Title - Sujet Palace Grand Theatre Foundation Rep	
Solicitation No. - N° de l'invitation EZ899-152418/A	Amendment No. - N° modif. 005
Client Reference No. - N° de référence du client	Date 2015-07-03
GETS Reference No. - N° de référence de SEAG PW-\$PWY-022-7522	
File No. - N° de dossier PWY-5-38030 (022)	CCC No./N° CCC - FMS No./N° VME
Solicitation Closes - L'invitation prend fin at - à 02:00 PM on - le 2015-07-10	Time Zone Fuseau horaire Pacific Daylight Saving Time PDT
F.O.B. - F.A.B. Plant-Usine: <input type="checkbox"/> Destination: <input checked="" type="checkbox"/> Other-Autre: <input type="checkbox"/>	
Address Enquiries to: - Adresser toutes questions à: Arthur (PWY), Carolyn	Buyer Id - Id de l'acheteur pwy022
Telephone No. - N° de téléphone (604) 775-6667 ()	FAX No. - N° de FAX (604) 775-6633
Destination - of Goods, Services, and Construction: Destination - des biens, services et construction: Parks Canada - Palace Grand Theatre - Dawson City, YT

Palace Grand Theatre Foundation Replacement
Palace Grand Theatre, Dawson City, YT

STRUCTURAL ADDENDUM

Project title/Titre du projet PALACE GRAND THEATRE FOUNDATION REPLACEMENT DAWSON CITY YUKON TERRITORY	Drawing title/Titre du

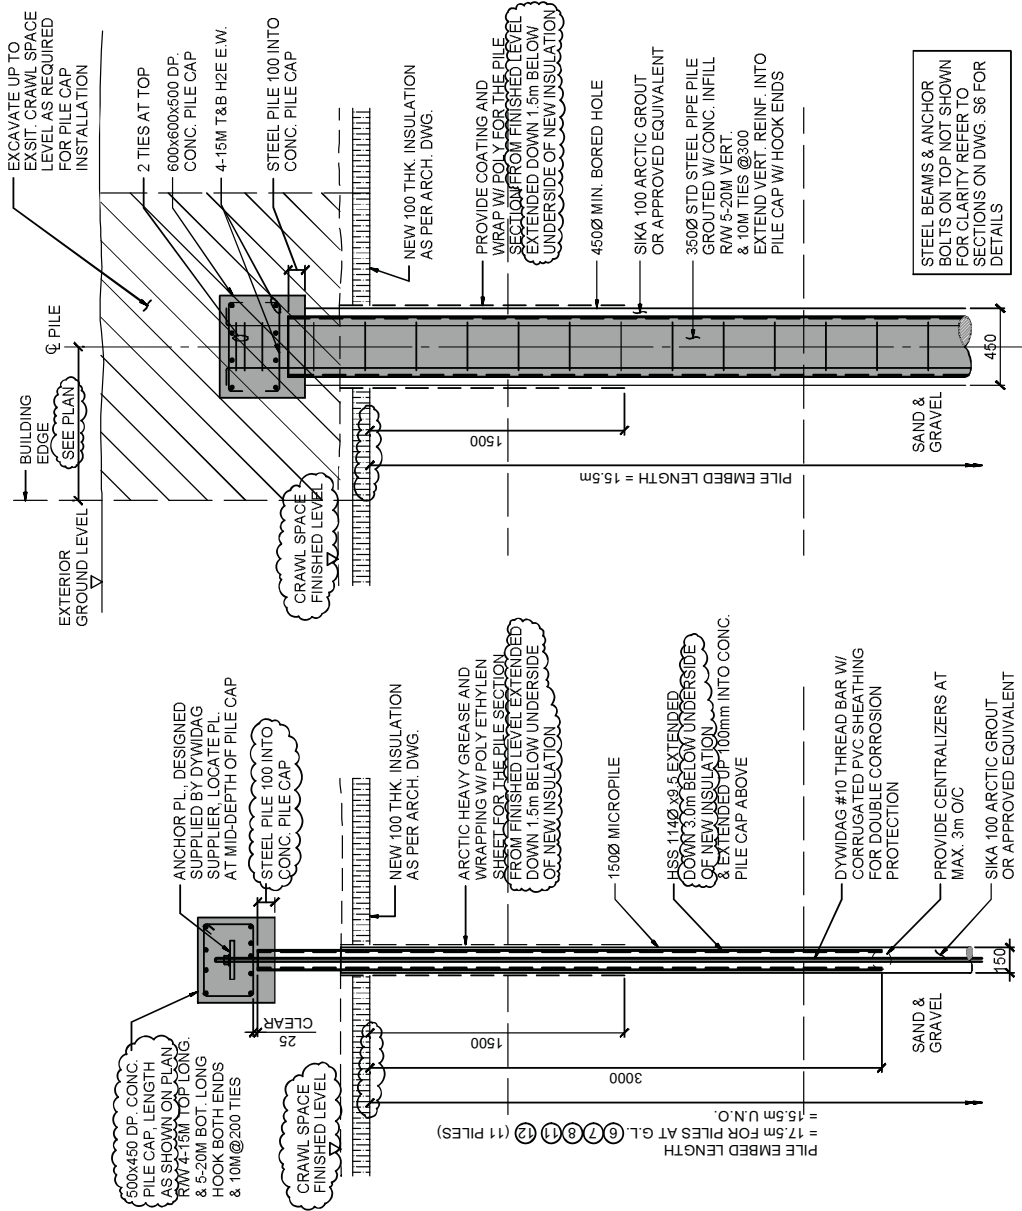
1. **Clarify** that the pile embedment depth, HSS extension and the coating & poly wrap shown on the typical pile details is measured from the underside of 100mm thick new insulation under the crawl space finished floor level and others as shown on the attached addendum sketch AD-S01.
